SERVICE No. 1035 BULLETIN

Distribution of Textron Lycoming Service Bulletin 529A, "Reprint of Crane/Lear Romec Service Bulletin No. 101SB020, Rev.2"

Service Bulletin No. 529A
(Supersedes Service Bulletin No. 529)
Engineering Aspects are
FAA Approved

FUEL PUMP – Torquing of Relief Valve Cover Screws.

Torquing Sequence – RG17980 Series
Figure 1

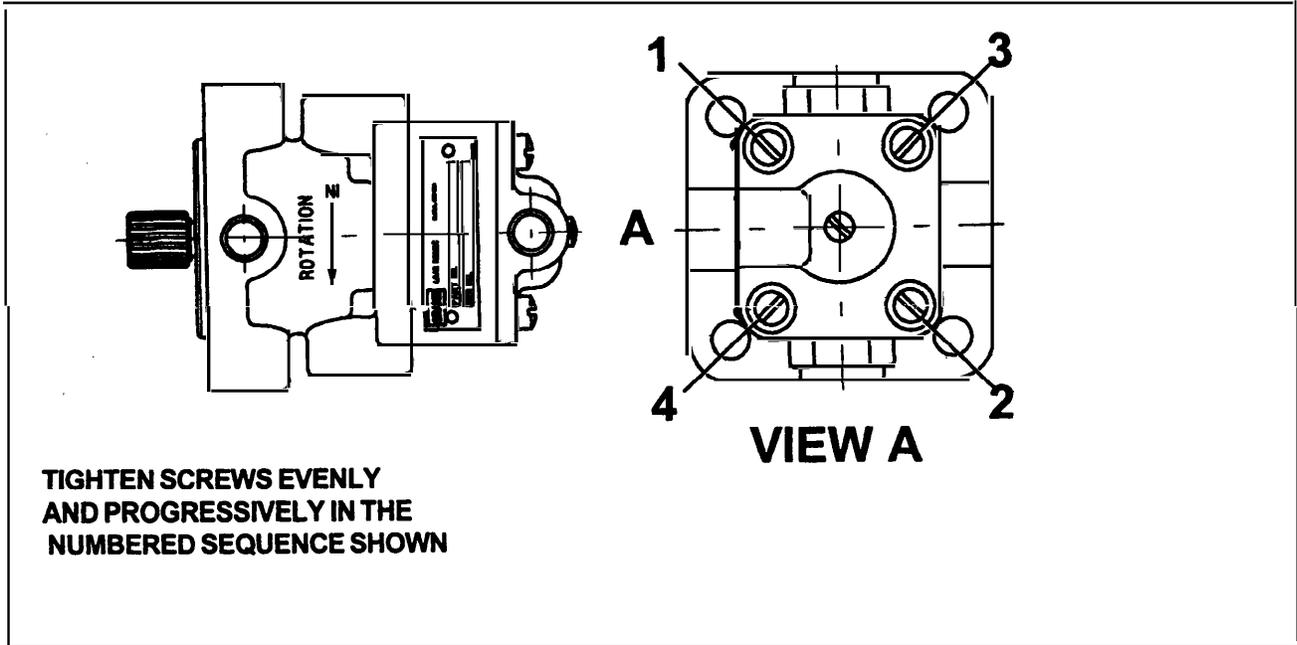
- (a) If pump is accessible without removing it from aircraft, the following check shall be performed.
- (b) Visually inspect the split line between the pump housing and relief valve housing for any evidence of noticeable gasket extrusion adjacent to the pump inlet & outlet ports. If there is evidence of noticeable extrusion, replace the pump per applicable engine maintenance instructions.
- (c) Check the tightness of relief valve cap attaching screws using a torque indicating screwdriver. Minimum torque shall be 23 inch-pounds. Torque shall be checked in the tightening direction.
- (d) If screws are loose, remove safety-wire and tighten screws evenly and progressively in a criss cross pattern to 23-25 inch-pounds torque in the sequence shown in figures 1 and 2.

- (a) Visually inspect the split line between the pump housing and relief valve housing for any evidence of noticeable gasket extrusion adjacent to the pump inlet & outlet ports. If there is evidence of noticeable extrusion, replace the pump per applicable engine maintenance instructions.
- (b) Check the tightness of relief valve cap attaching screws using a torque indicating screwdriver. Minimum torque shall be 23 inch-pounds. Torque shall be checked in the tightening direction.
- (c) If screws are loose, tighten screws evenly and progressively in a criss cross pattern to 23-25 inch-pounds torque in the sequence shown in figure 1 and 2.
